Proposed Revisions to a Standard Plans Index

Index Number: 536-001

Index Title: Guardrail

APPROACH TERMINAL ASSEMBLY 'DOUBLE FACED' SEGMENT - PLAN VIEW

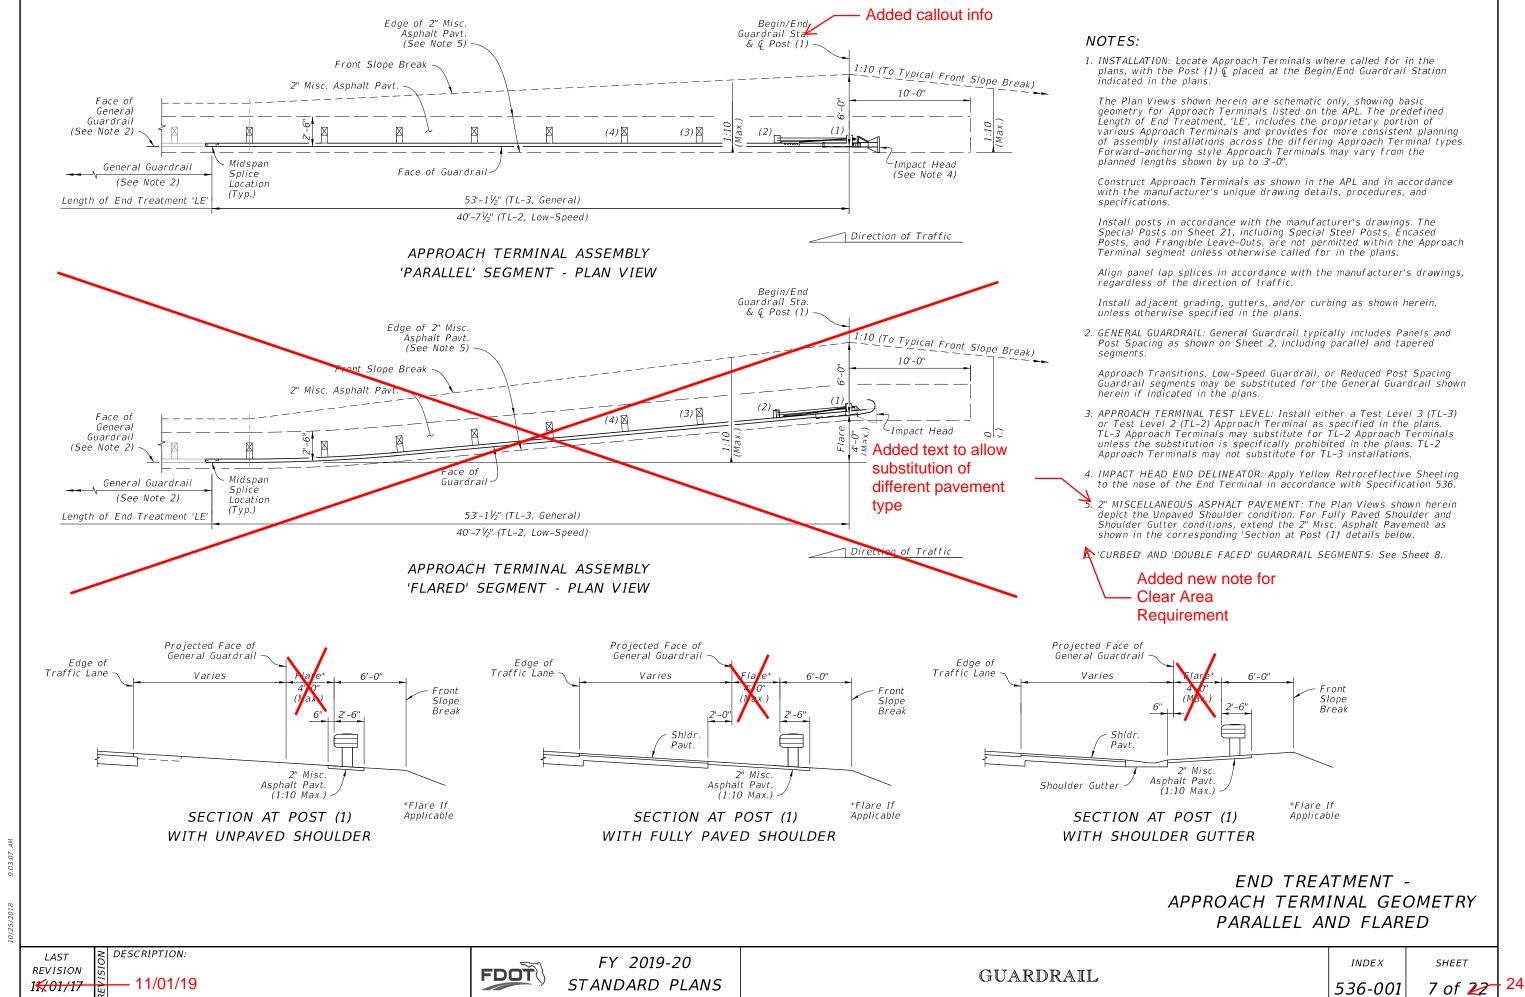
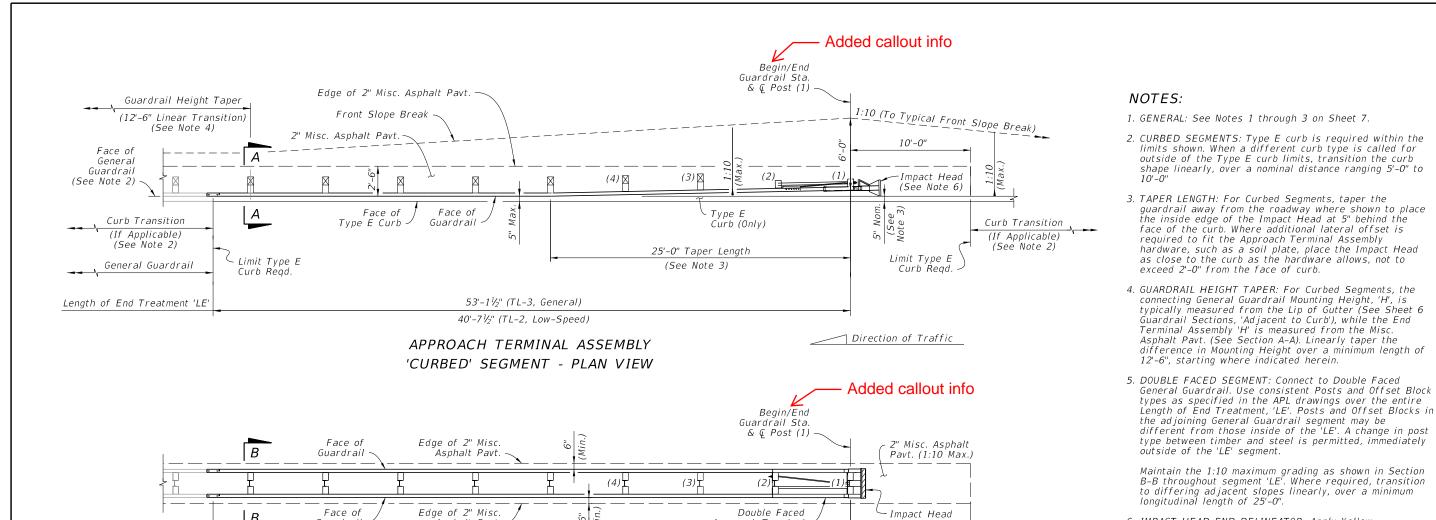
Added note to allow substitution of different pavement type

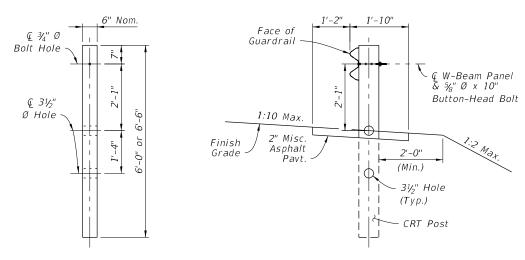
Added callout info

TL-2 APPROACH TRANSITION INSTALLED ELEVATION

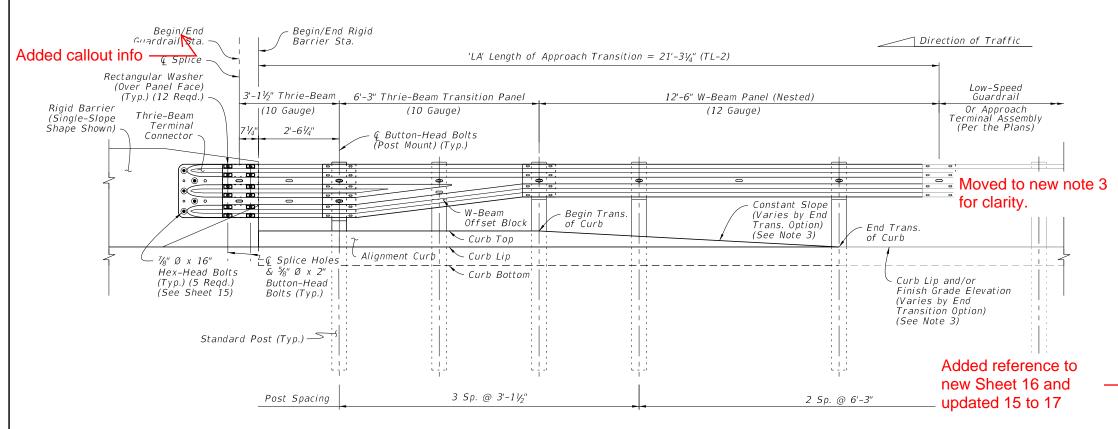
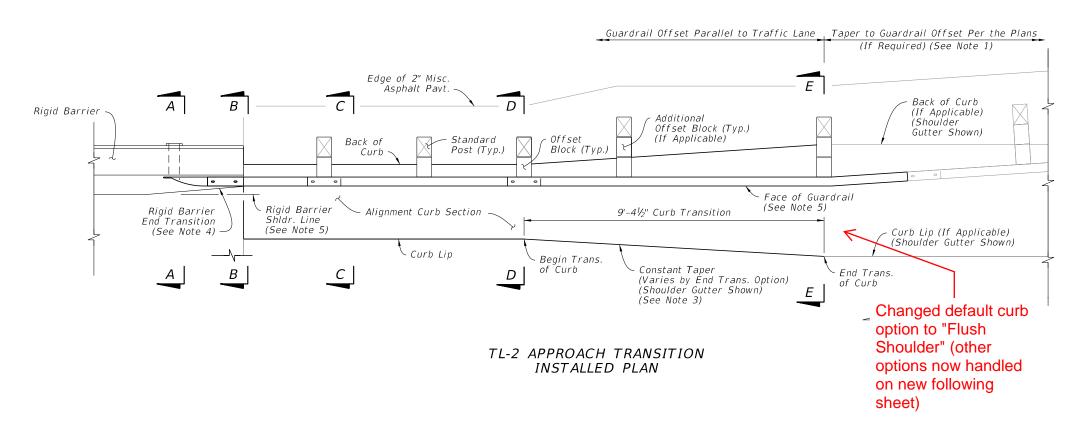
- 2. SECTION VIEWS & DETAILS: For cross sections and details including the barrier mounting bardware curb transition, adjacent grau Updated to Sheet 17 see Sheet 17

TYPE D TRAILING CONNECTION FROM RIGID BARRIER PLAN VIEW - MEDIAN OR OUTSIDE SHOULDER (Mirror Horiz. and/or Vert. for Opposite Direction and/or Side of Road)

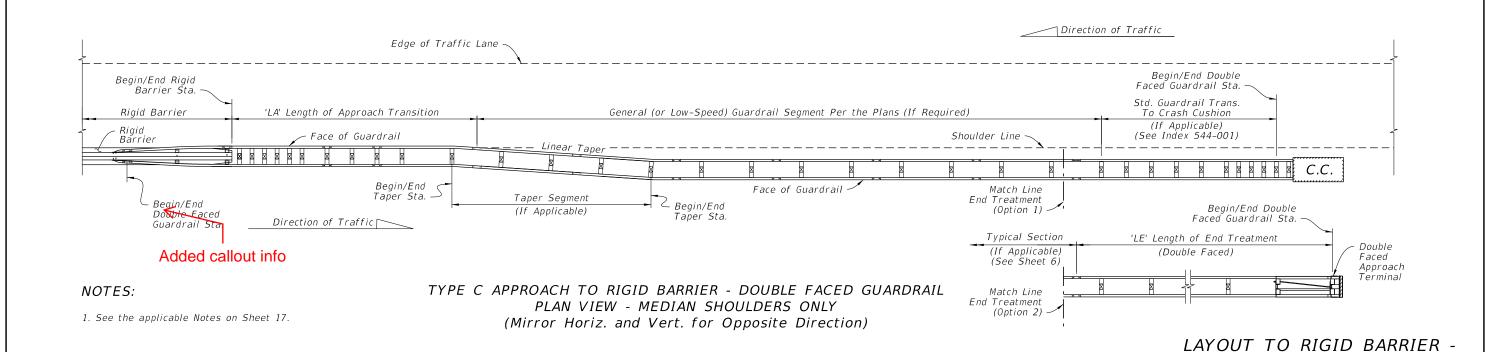
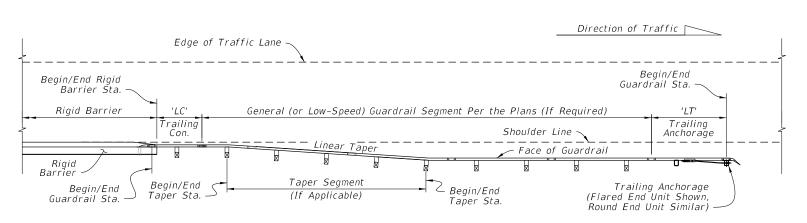
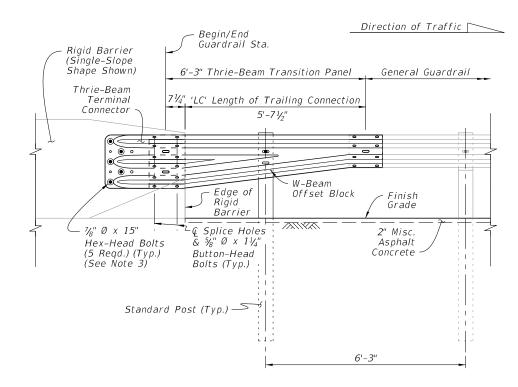
-Added "Trailing End Transition Connection to Rigid Barrier" to new Sheet 20
